BUFFALO RUN ACRES SUBDIVISION

CONSTRUCTION DOCUMENTS TAYLOR, WEBER COUNTY, UTAH

BUFFALO RUN ACRES SUBDIVISION
CONSTRUCTION DOCUMENTS

CE2-07

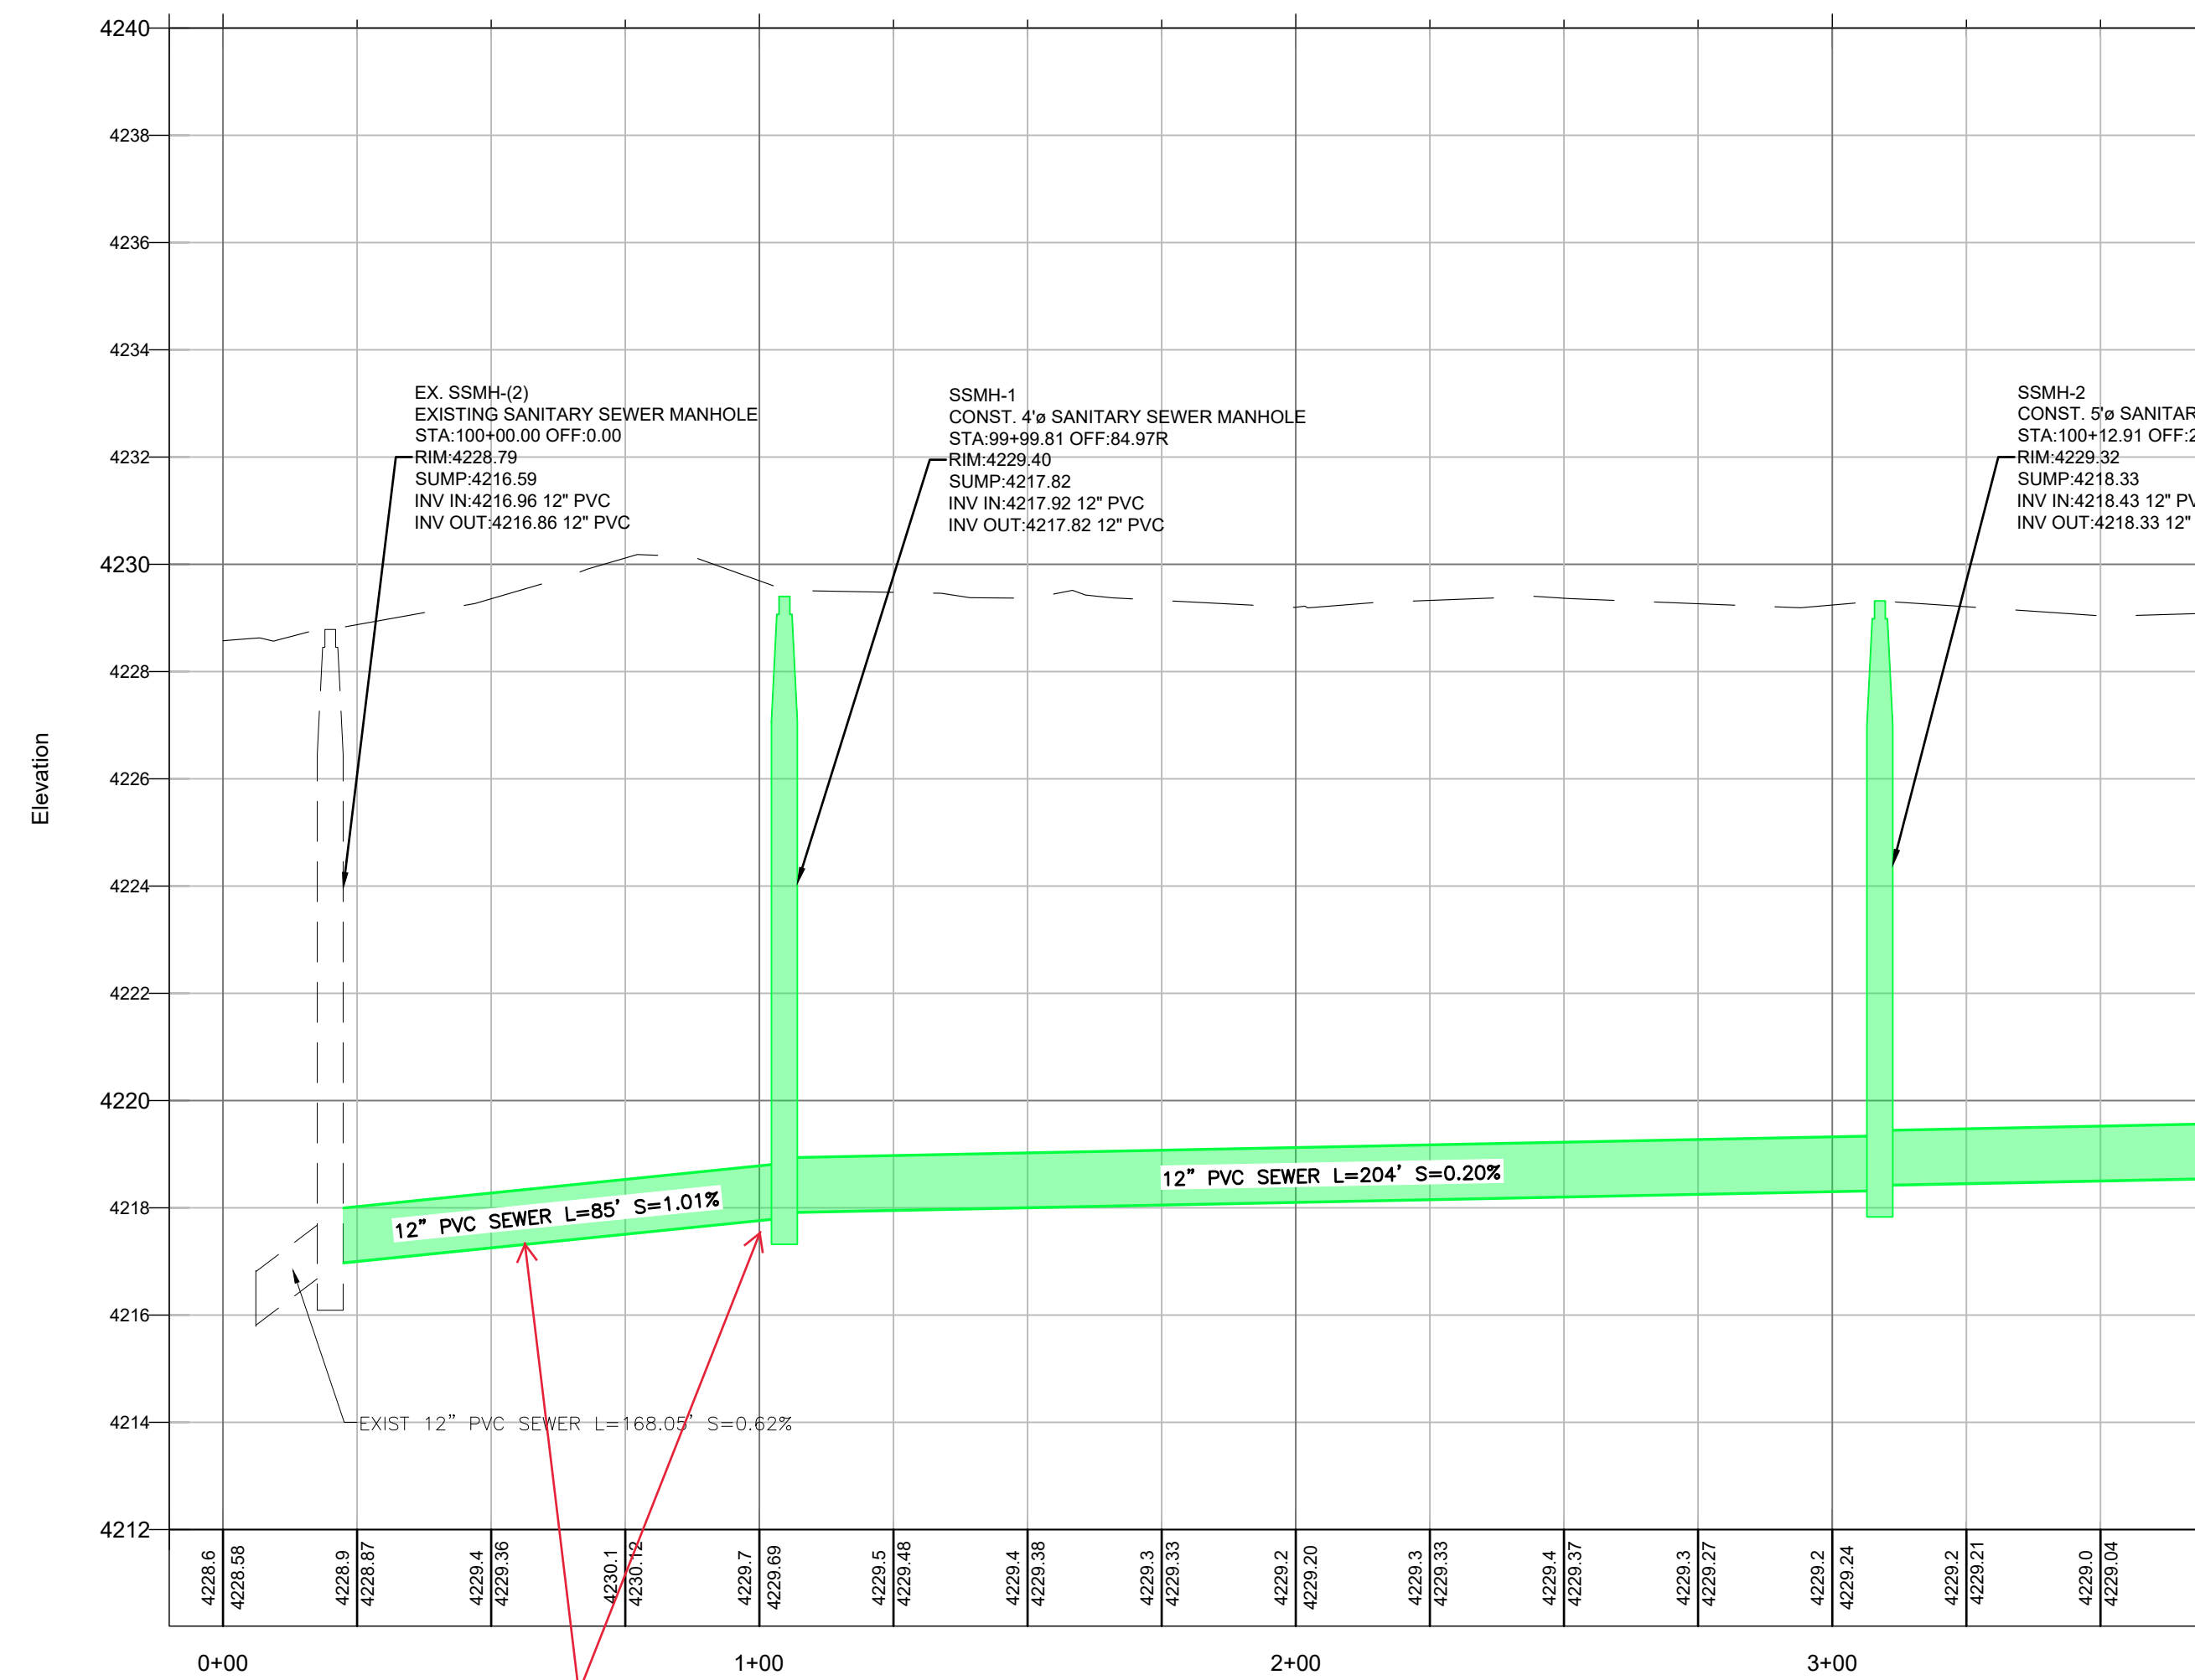
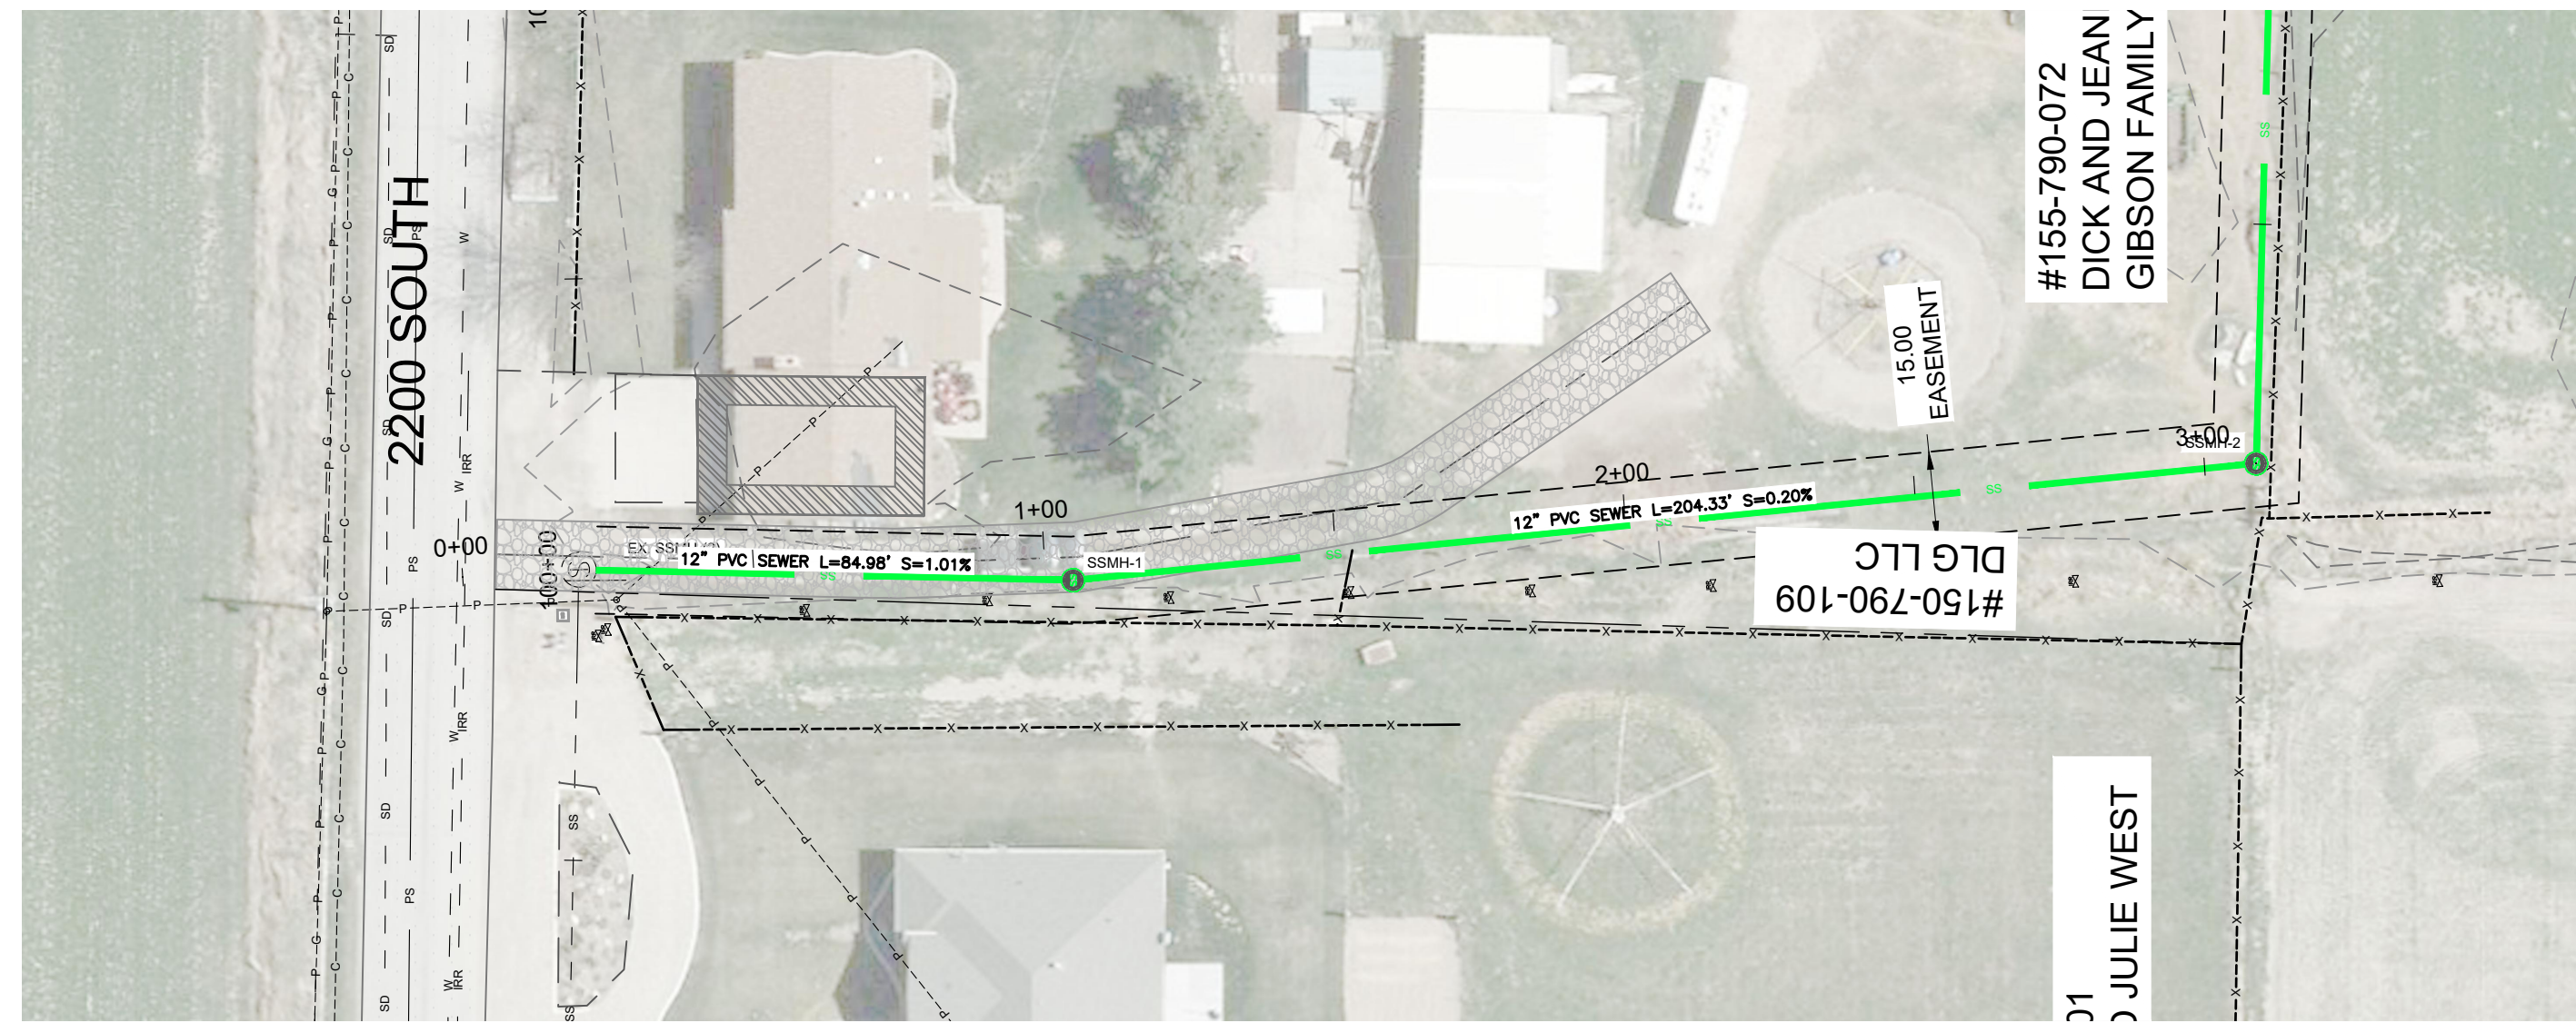
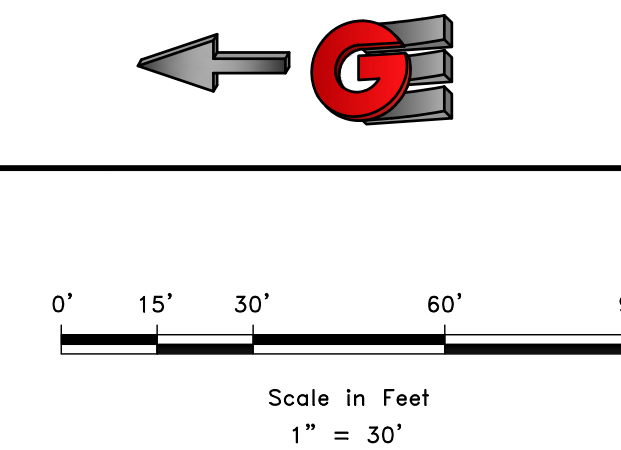
We need to find out if Dick Gibson is hooked to the sewer. If not we will want a sewer lateral stubbed to his house.

CE2-08

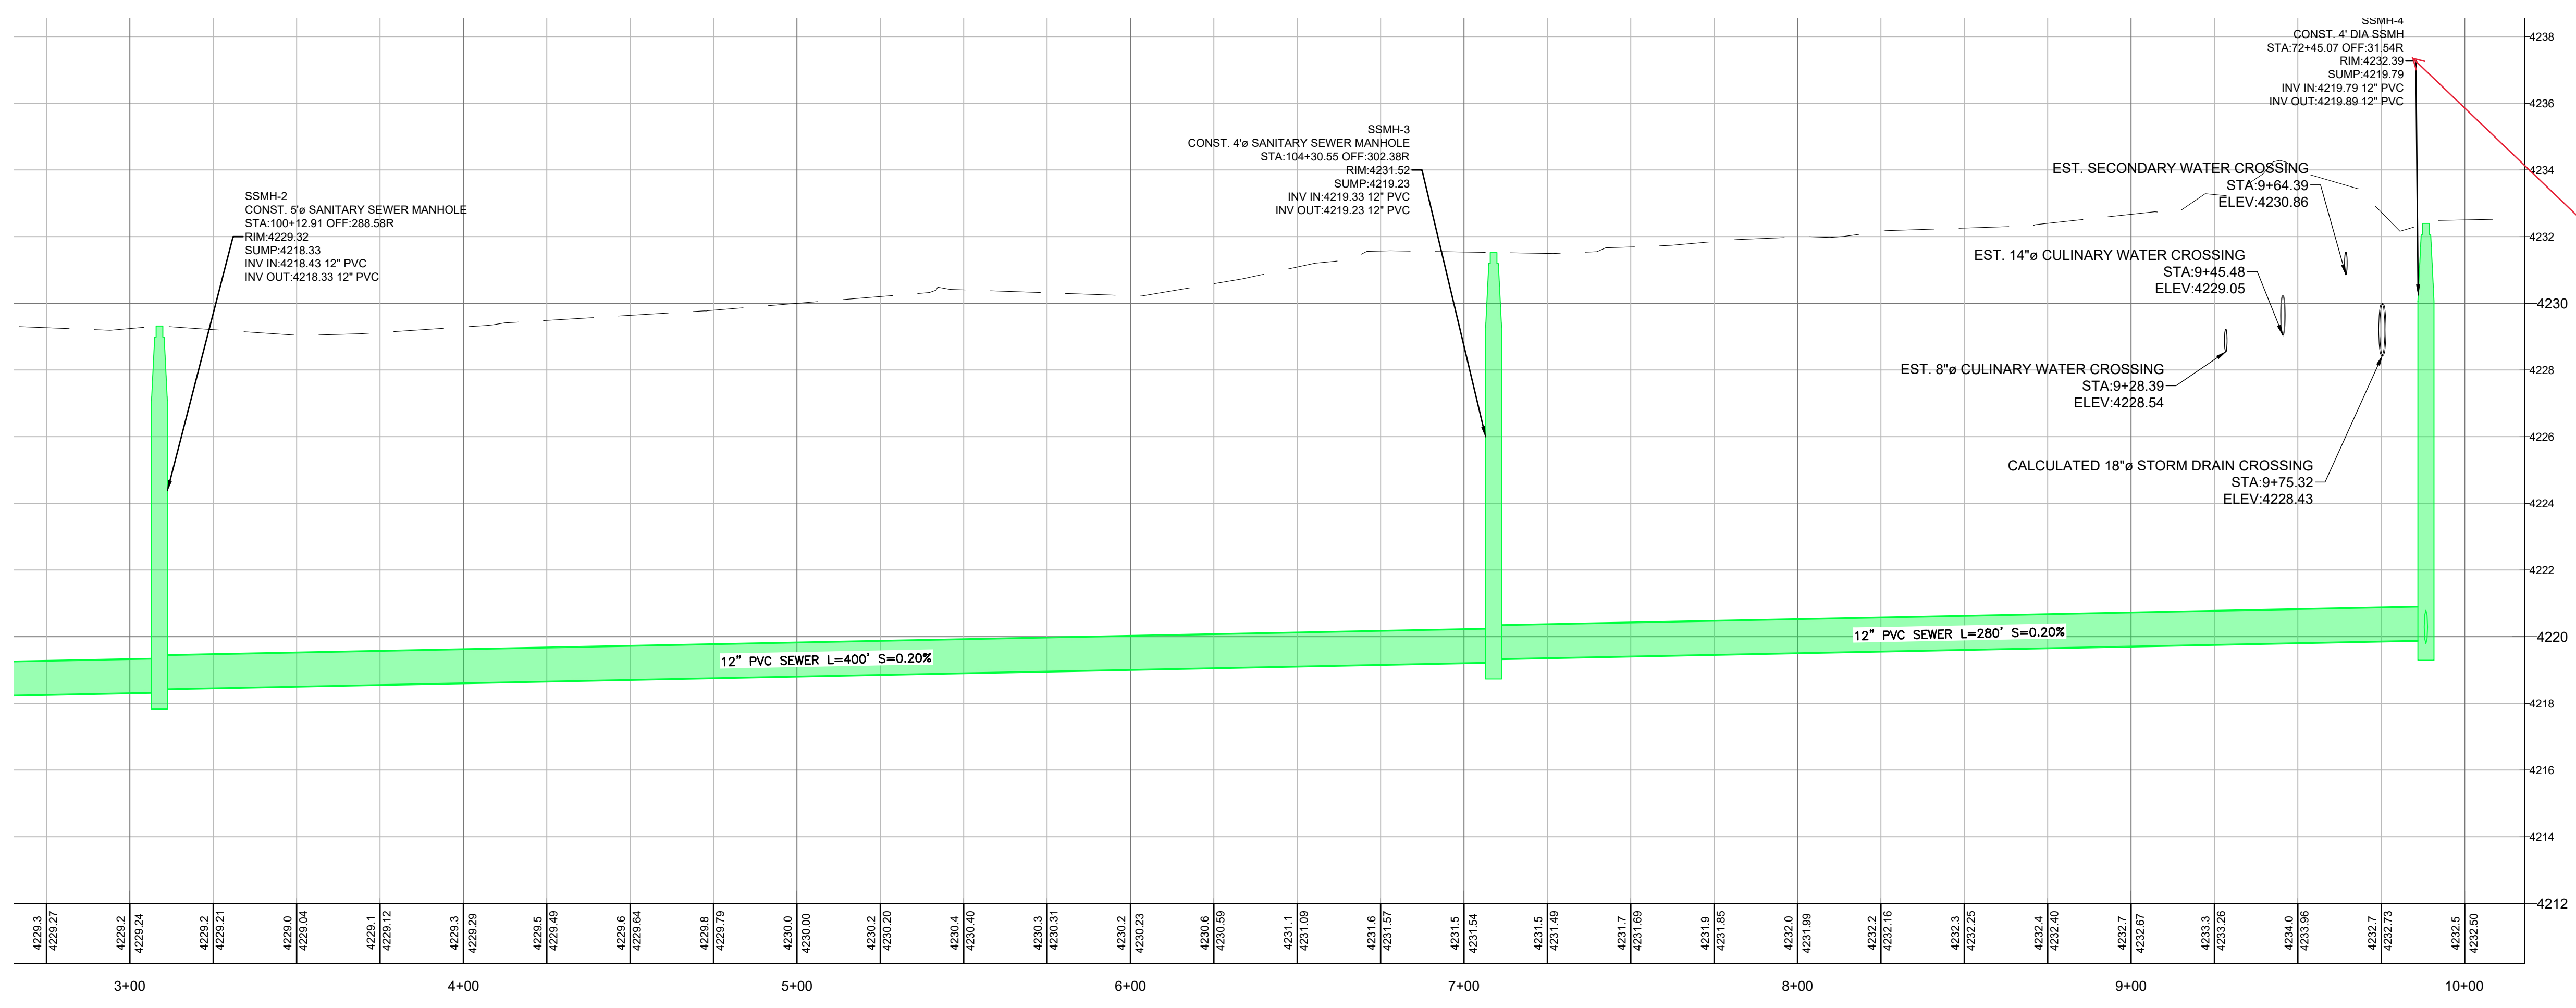
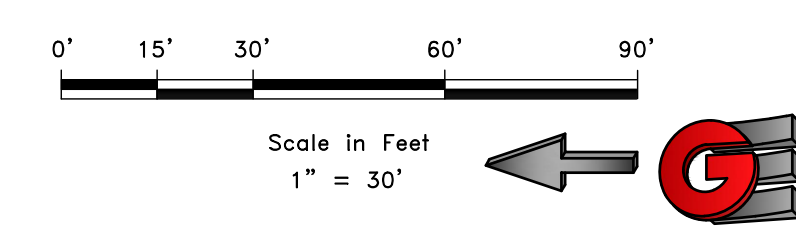
Show a casing for the Sewer crossing.

5' MH
